PUBLIC HEARING MEMORANDUM

SUBJECT: **Petition #388-21** to construct an addition to the existing structure and a second two-unit structure, allowing four single-family attached dwelling units in two buildings, to allow reduced side and rear setbacks and to allow a driveway within ten feet of the side lot line at **300 Elliot Street**, Ward 5, Newton Upper Falls, on land known as Section 51 Block 38 Lot 19, containing approximately 19,057 sq. ft. of land in a district zoned MULTI RESIDENCE 1. Ref: Sec. 7.3.3, 7.4, 3.4.1, 3.2.4, 6.2.3.B.2, 5.1.8.A.1, 5.1.13, 5.1.8.A.2, 5.1.8.B.1, 5.1.8.B.2, 5.1.8.D.1, 5.1.8.E.1, 1.5.4.G.2.a, 1.5.4.G.2.b of Chapter 30 of the City of Newton Rev Zoning Ord, 2017.

300 Elliot Street

Proposed site plan

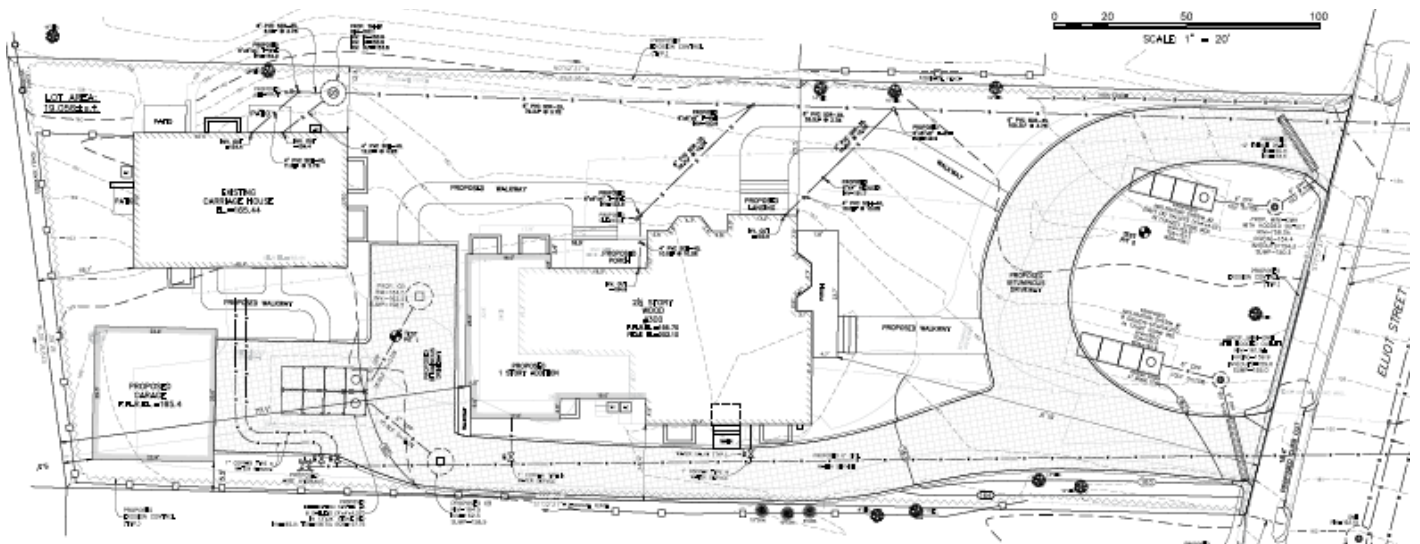
The petitioner proposes to construct a circular drive at the front of the property, both sides of which would be located within ten feet of the side lot lines. Also, the proposed two-way driveway would continue along the left (east) side lot line to the rear of the property to serve the proposed two-car garage. The driveway narrows to 10 feet wide at the left side of the front dwelling but otherwise measures 12 feet in width (less than the by right minimum width of 20 feet for two-way driveways).

Two of the six surface parking stalls would be located within 20 feet of the side lot lines and within a side setback. Two stalls would be located within five feet of a structure containing dwelling units, one just to the rear of the front dwelling, another just in front of the rear dwelling .

Four of the six surface parking stalls would have a width of 8 feet, less than the 9 feet required; two angled surface parking stalls and two parallel stalls would have with depths of 18 feet, less than the 19 and 21 feet respectively required. Two surface stalls would be established directly in front of the proposed two-car garage, creating two pair of tandem stalls.

That said, the Planning Department does have some concerns regarding the submitted turning templates as they do not seem to contemplate the tandem spaces that would be located in front of the proposed garage and, as such, some of the depicted maneuvers seem impractical if vehicles were occupying those tandem stalls. The Planning Department recommends the petitioner revisit the placement of some exterior parking stalls to address this issue.
